RESPONSE TO AUDIT ISSUES

APR1400 Topical Reports

Review Section	TR Realistic Evaluation Methodology for LBLOCA of the APR1400
Application Section	Topical Report: APR1400-F-A-TR-12004 Realistic Evaluation Methodology for Large-Break LOCA of the APR1400
Issue Date	08/13/2015

Audit Issues No. 5

Figure 1. The conventional noding diagram of UGS []^{TS}

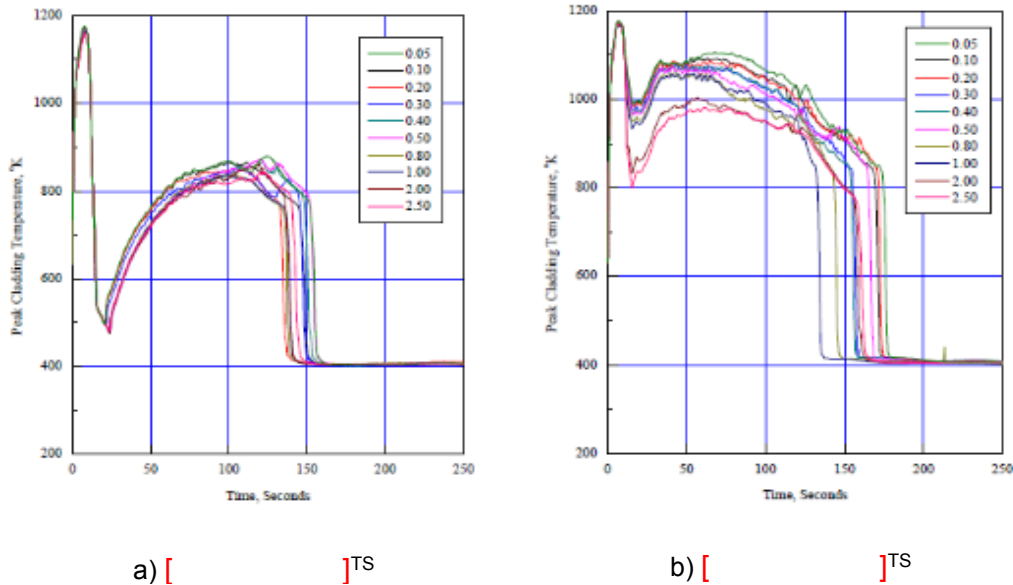
The guidance in RG 1.157, Section 4.3.1 establishes acceptable controls for the utilization of conservative parameters in best estimate analysis. The topical report states that the methodology is best-estimate. However, the actual implementation of the methodology incorporates a mixture of best-estimate and conservative assumptions. The reason for the conservative treatment is provided for only certain parameters. The Applicant will need to provide the basis and justifications for the selecting the parameters to be treated conservatively instead of a best-estimate manner, involving the quantification and propagation of uncertainties.

The upper head water can flow down to the upper plenum and may affect the core cooling behavior during blowdown. This phenomenon is considered by the nodding scheme. By performing several sensitivity studies on the nodalization of upper guide structure (UGS, the volume between upper guide structure support plate and inner vessel assembly), the nodding that gives the most conservative result is determined. The limiting UGS nodding is used for the plant calculation of the topical report. Figure 1 and Figure 2 show the conventional nodding scheme and the most conservative nodding scheme, respectively. Figure 3 shows the effect of the nodding scheme on the cladding temperature. Although reflood PCT is changed more, the phenomenon is important for blowdown because the phenomenon is related with blowdown quenching. The category of conservatism of this phenomenon belongs to Category 2.
